“JIB” Property Waterfront Amenity Phase I

Addendum No. 3

25 January 2013

Project: "JIB" Property Waterfront Amenity Phase I

R-1

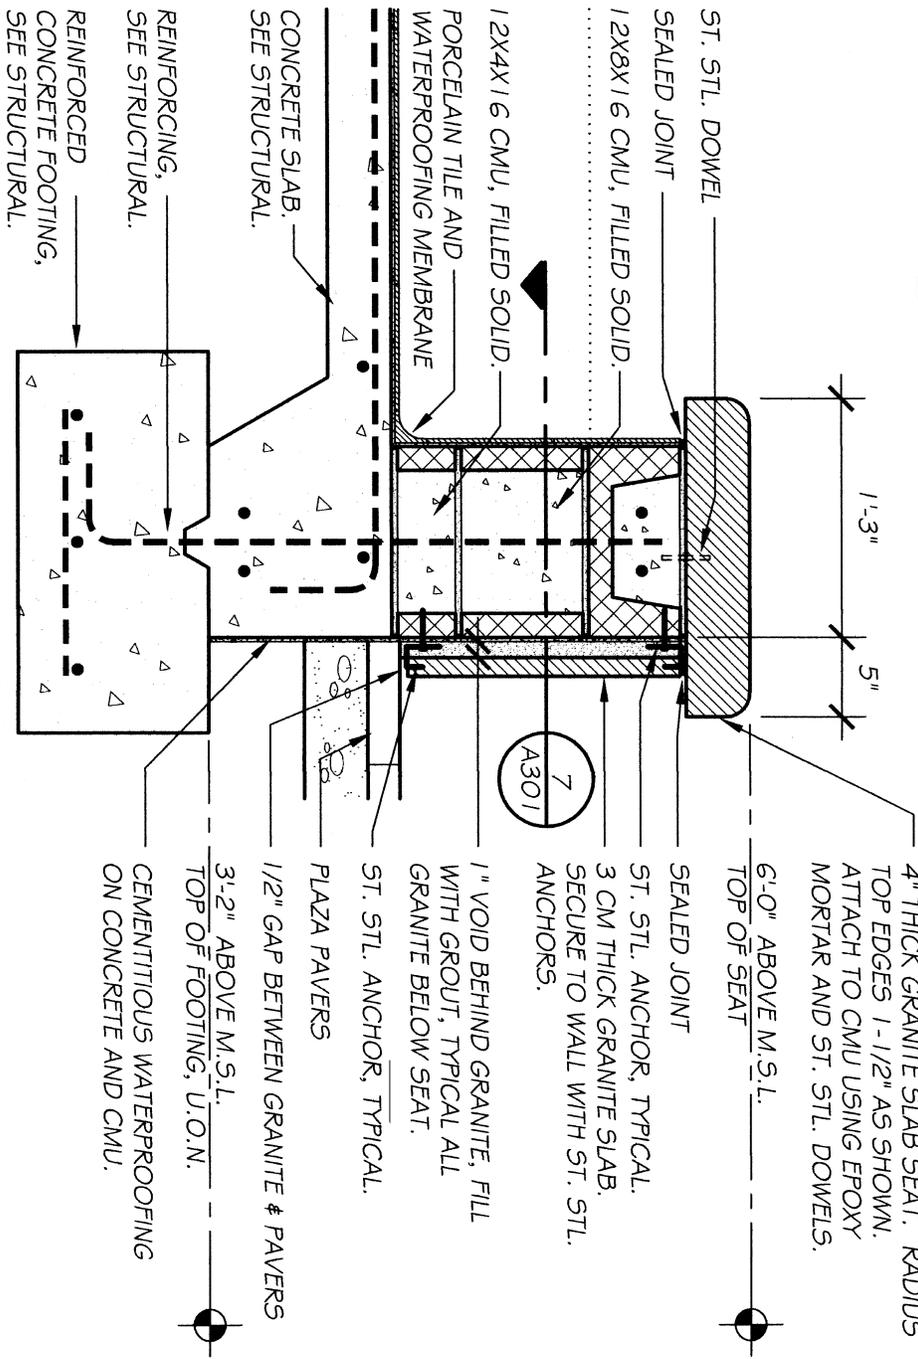
DRAWING SHEET A-301 – DETAILS 3/A301 & 7/A301 are revised as per attached Drawing Sheet R-1. Granite below seat changes from ¾" thick to 3CM (1.18"), and attachment method changes from epoxy to stainless steel anchors and grout.
